*Diabase Quarry Report of Professional Opinion*

## **H&K Quarry Project**

Springfield Township, Bucks County, PA

Diabase Quarry Report of Professional Opinion

Geologic Features Map

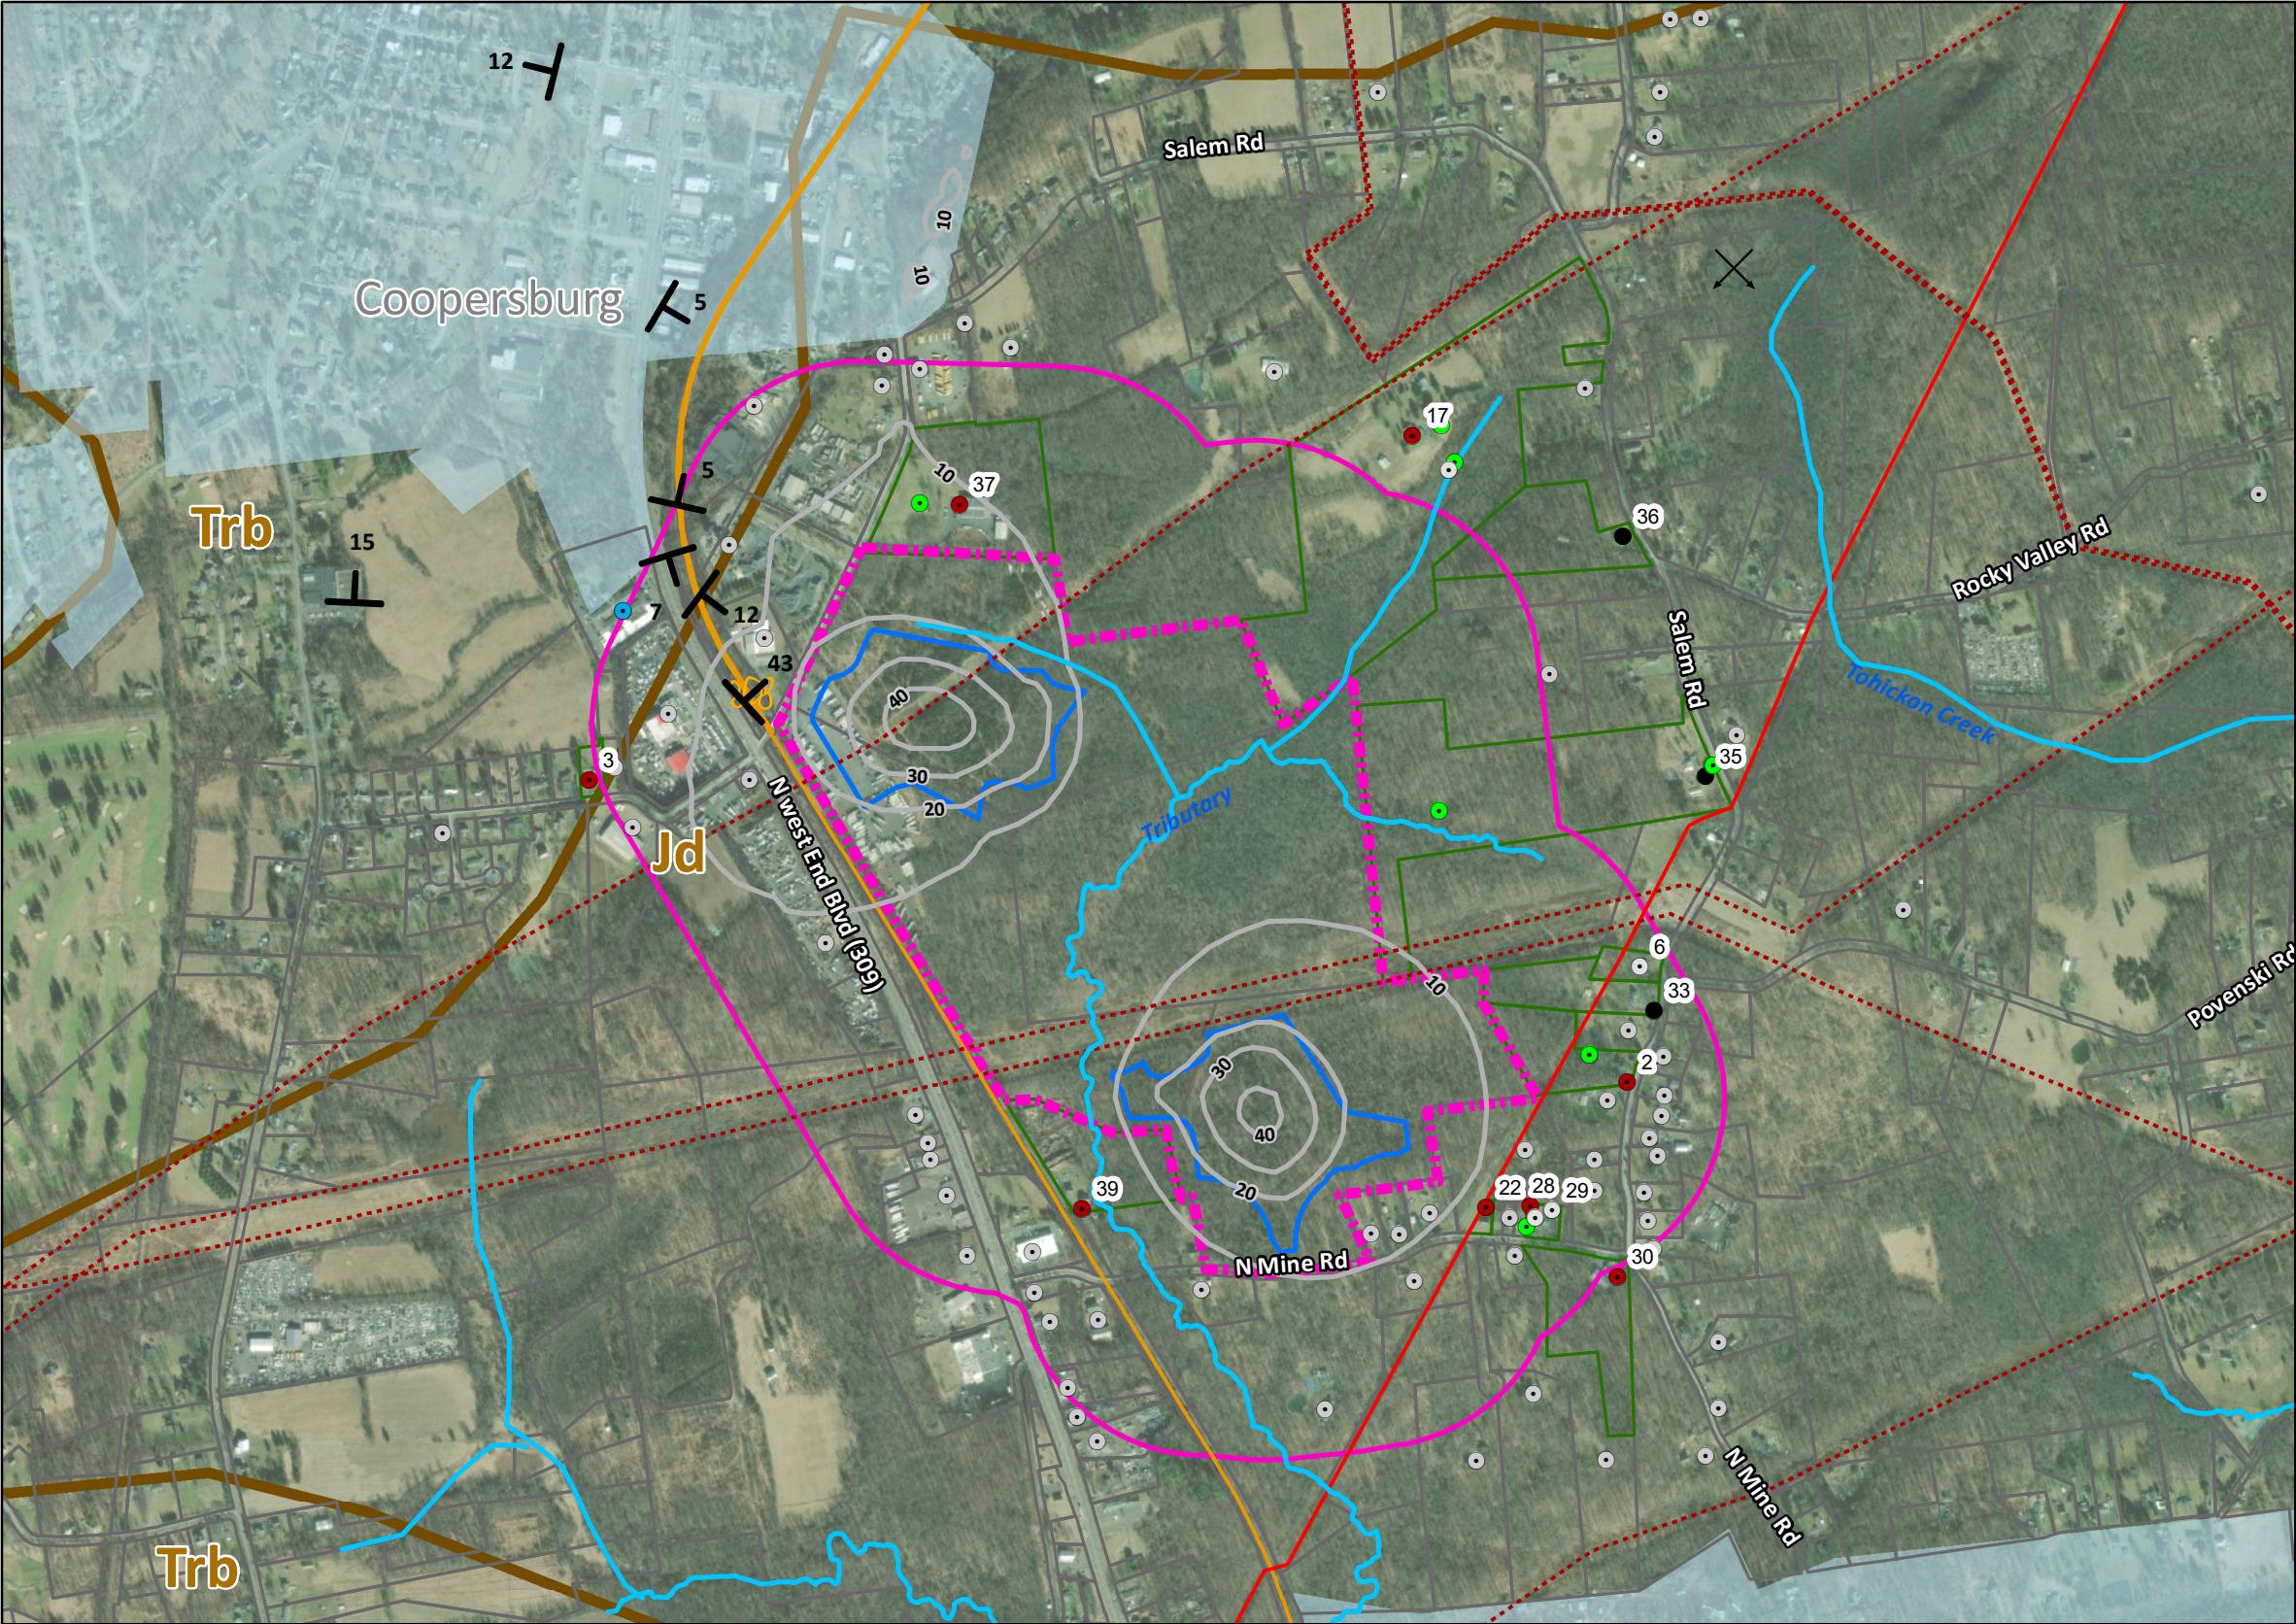
The desktop references cited by the Britton report did not rely on published geologic thicknesses data from multiple Bucks County sources (Schreffler, 1996, Lyttle and Epstein, 1987, Drake 1999, Bascom et al, 1931 pg. 38). Field measured thickness values or geologic boreholes on the quarry site were not described in the Britton report. The feasibility of an approach to deepen wells impacted by the quarry is risky for this reason. Geologic conditions within the study area are shown on Figure 1.

**Figure 2:**  
Hydrogeologic Map  
February 07, 2022

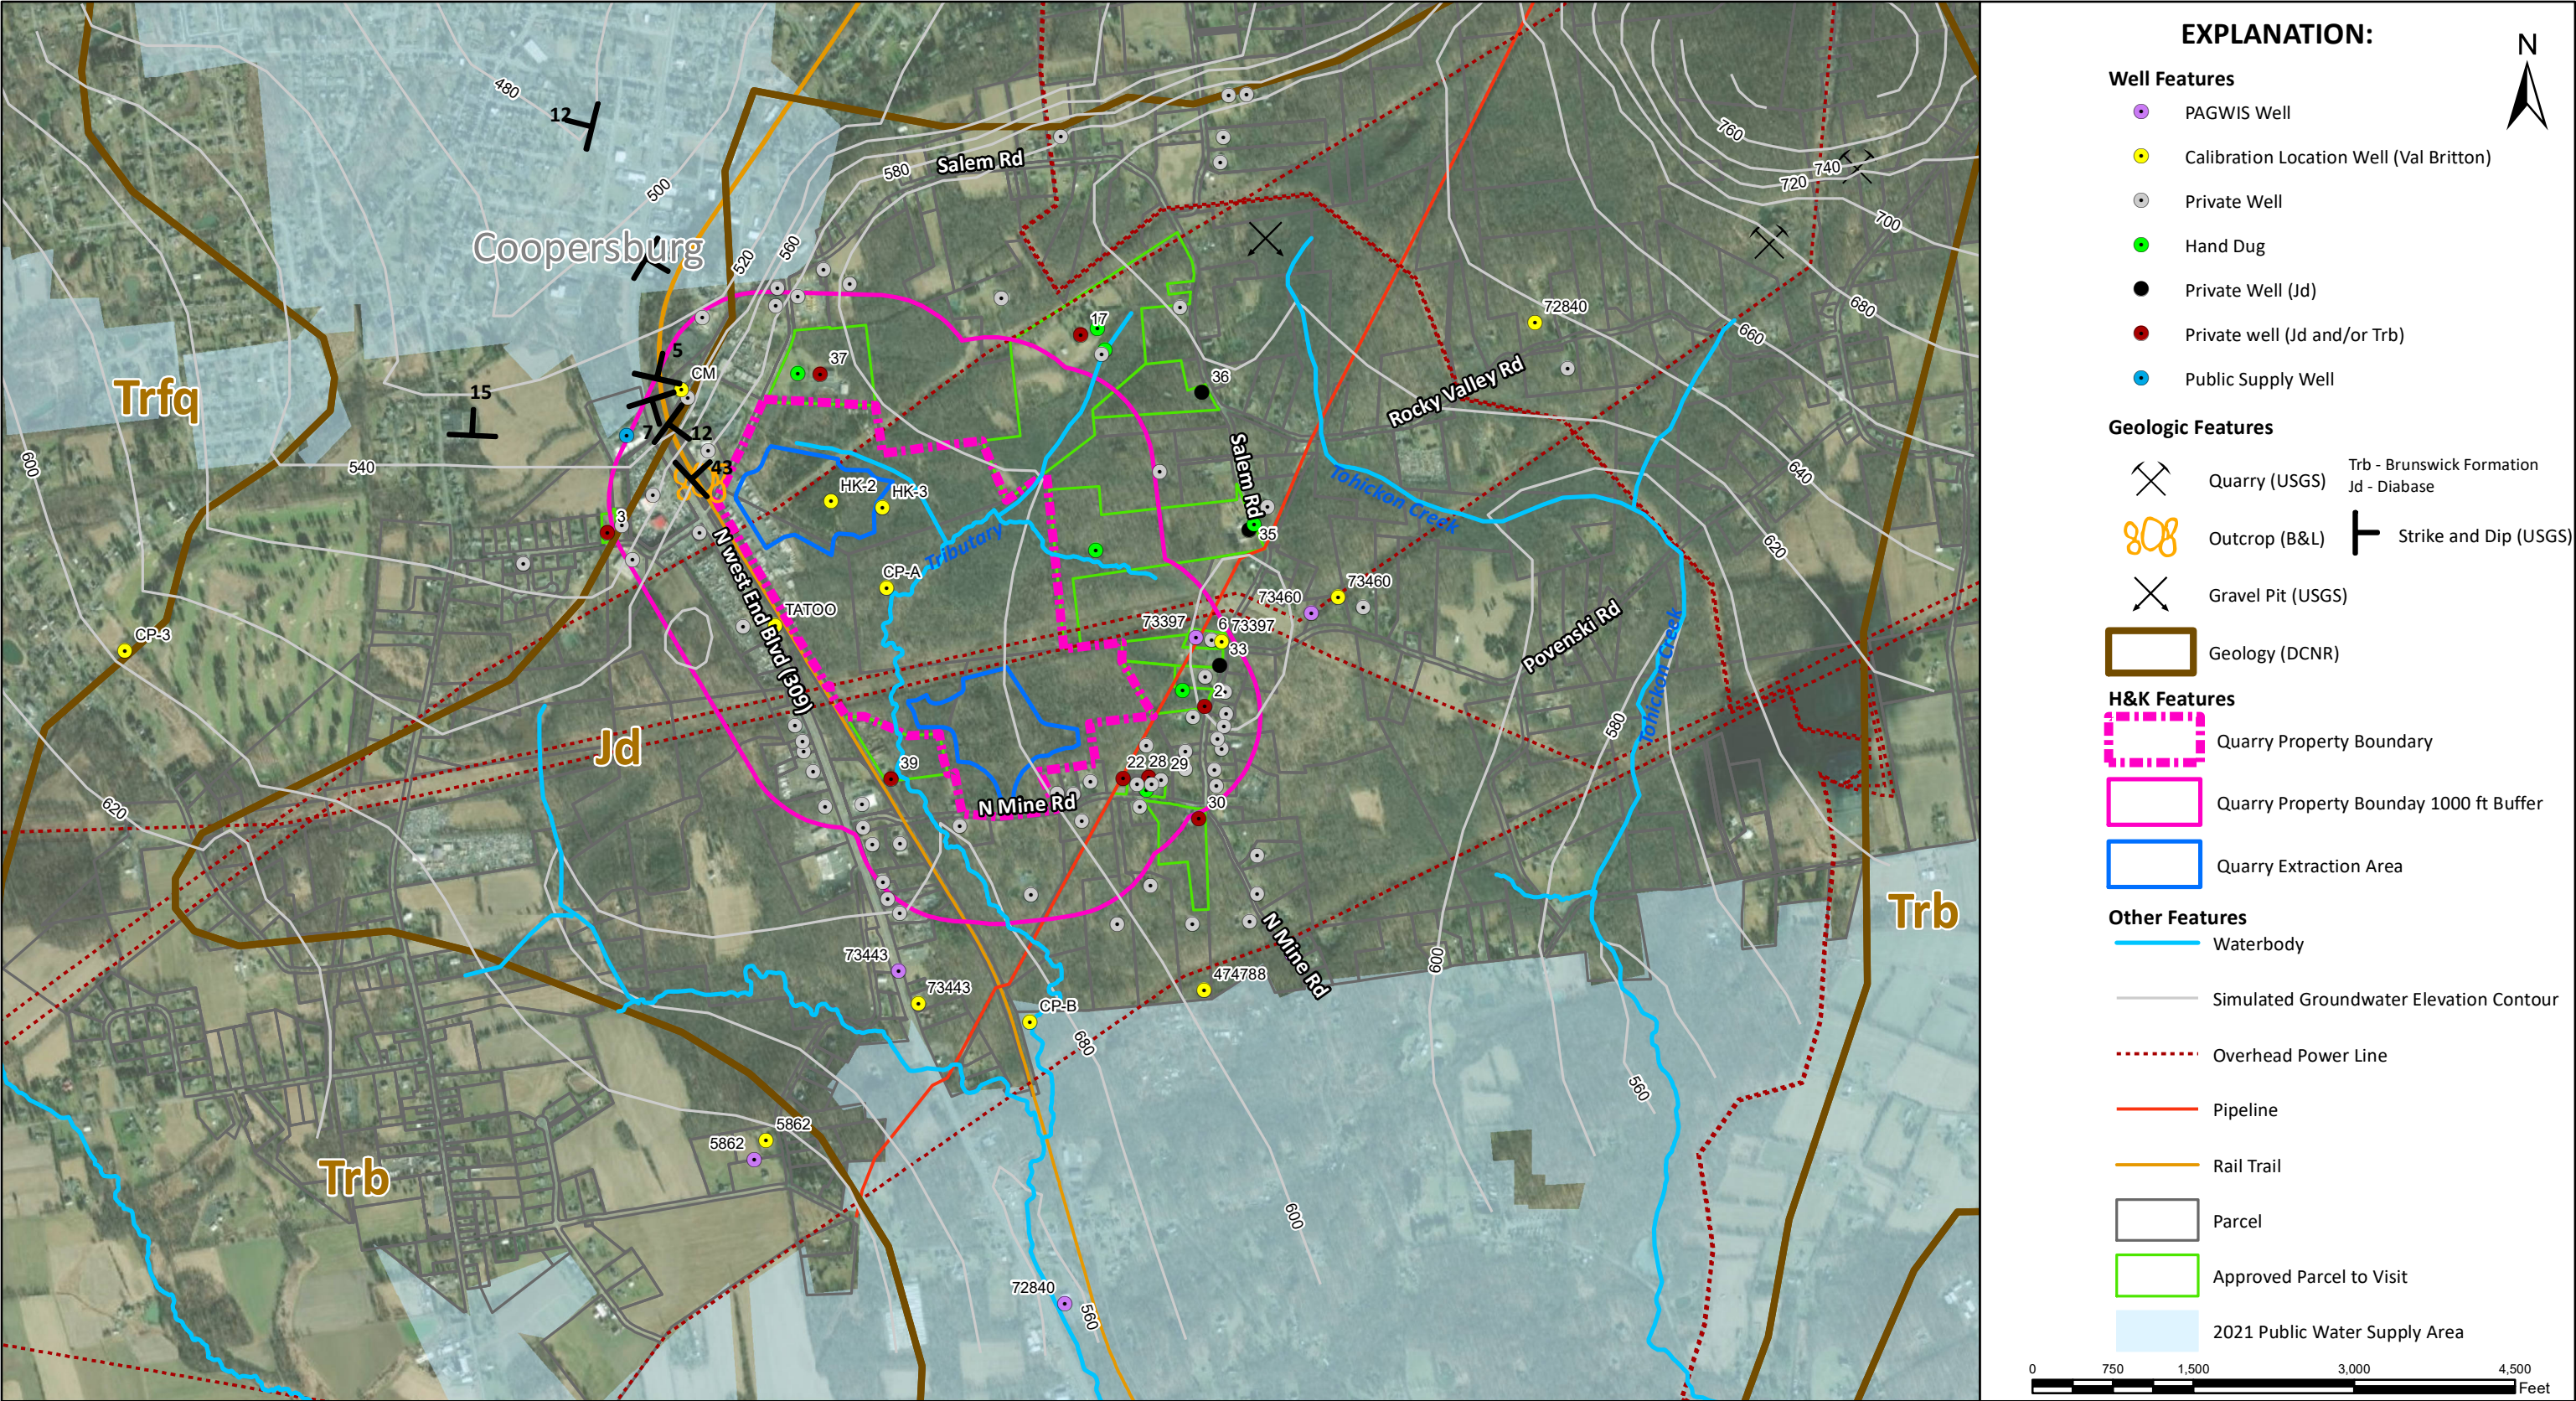
Figure 2 shows well points from improved lots with boundaries touching the 1000-foot radius, but PAGWIS records for these wells was limited. Improved properties shown on the H&K site plan not within the Coopersburg and Springfield public supply service areas likely have wells. Of the estimated 63 drilled wells identified (Figure 2), I visited 14 wells to GPS locate and measure water levels (Table 1). For these 14 wells, I searched PAGWIS for additional well data (Table 2) and relied on data provided by well owners (Table 1). Only 4 out of the 14 GPS-located wells or about 30% of the wells data were recovered in the PAGWIS database. Of those recovered, the PAGWIS locations compared to our GPS locations were off by approximately 60 to 260 feet. The water levels recorded also showed differences (Table 2). These data illustrate the limitations of relying on PAGWIS for modeling purposes. The locations may not be accurate, and data may not readily available for each well point.

Most of the wells within the study area were not used in the calibration of the model, making the modeled results not very representative of the areas with domestic wells. The neighboring properties and water supplies are at risk of because the drawdown predictions are not based on many calibration points. Calibration wells represented 12% of the estimated 63 wells identified within 1,000 feet of the quarry. Again the Britton model was calibrated using data from only eight wells out of 63 potentially available (Figure 2).

The preliminary groundwater model may not reliably predict conditions during below or above average scenarios, placing wells at risk or experiencing drawdown that differs from the modeled condition. Figure 2 illustrates the H&K preliminary model calibration simulated groundwater contours. Table 2 compares B&L-collected water levels to the model simulated levels. This demonstrates a poor correlation between the simulated condition and B&L-observed condition, representing a wet weather period. Drier weather observation may have a similar outcome.
